APPLICATION NUMBER: RECON 24/0678

PROPOSAL: PROPOSED DEVELOPMENT OF 42 NO. DWELLINGS, LANDSCAPE PLANTING AND ASSOCIATED WORKS

SITE: Monbank Development Site Cardiff Road

CLARIFICATION IS STILL REQUIRED

The Boundary Identification Detail plan by Le Trucco Design is helpful.

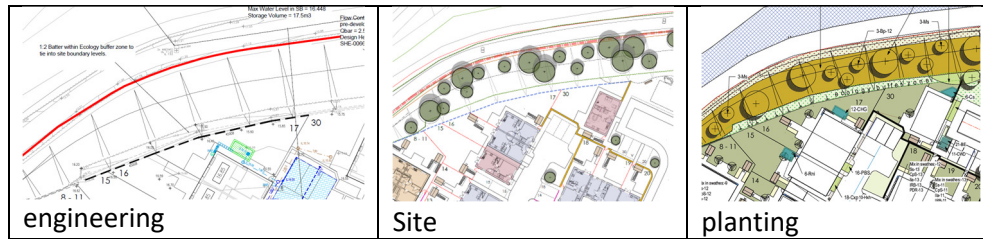
The site has difficult levels to deal with key levels are not shown on the Site Plan.

The proposals show the steep 1 in 2 slope along the north boundary, with (up to) 450mm height gravel board and 2.4m acoustic fence at the top of the slope. There is planting to the slope and a grass verge to the base but given the steepness I would query whether any further drainage is needed to prevent water/soil washing onto the cycle path.

Similarly difficult levels are shown to the rear gardens of plots 1-12 south. A slope is shown within the rear gardens down to retaining walls (possibly gabion baskets) up to 750mm height with retained vegetation immediately beyond. The slopes will be difficult to maintain and will not provide useable space.

Sections through the west and north boundaries would help show the relationship between all of the proposals and the existing and proposed levels which is otherwise difficult to interpret across the various plans.
